Product Change Notification

Thank you for choosing KYOCERA as your LCD solution provider. We appreciate the opportunity to support your business. This letter is to inform you of a product packaging change.

TCG121XGLPAPNN-AN20	12.1" XGA, 400nits, AWW
TCG121XGLPBPNN-AN40	12.1" XGA, 1200nits, AWW, CCC
TCG121XGLPCPNN-AN70	12.1" XGA, 1200nits, AWW
TCG121XGLPAPNN-AN20-SA	12.1" XGA, 400nits, AWW

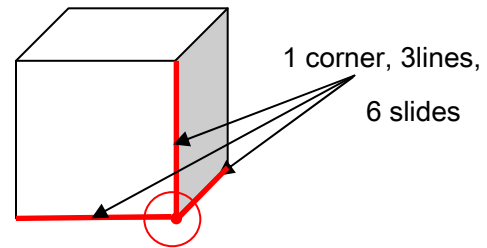
- Box qty and protective insert change

Current: 10pcs / box (1 row x 10pcs) , 14kg

New: 14pcs /box (1 rows x 14pcs) , 14kg

- Box dimension change:

Current (L x W x H): 410 mm x 495 mm x 331 mm

New (L x W x H): 310 mm x 535 mm x 336 mm

We implemented the following test to verify the effect of the change.

Packaging Drop Test Conditions

Height : 100cm

Side of the drop and number of the drop :

1 corner, 3 lines, 6 sides (Total 10 times.)

Conditions: Packaged condition

Confirmation and Result

<Confirmation>	<Result>	<Quantity>
Functional Defect	No defect	14pcs
Display Mura	No defect	14pcs
Case Deformation	No defect	14pcs
Damage of Mounting Component	No defect	14pcs
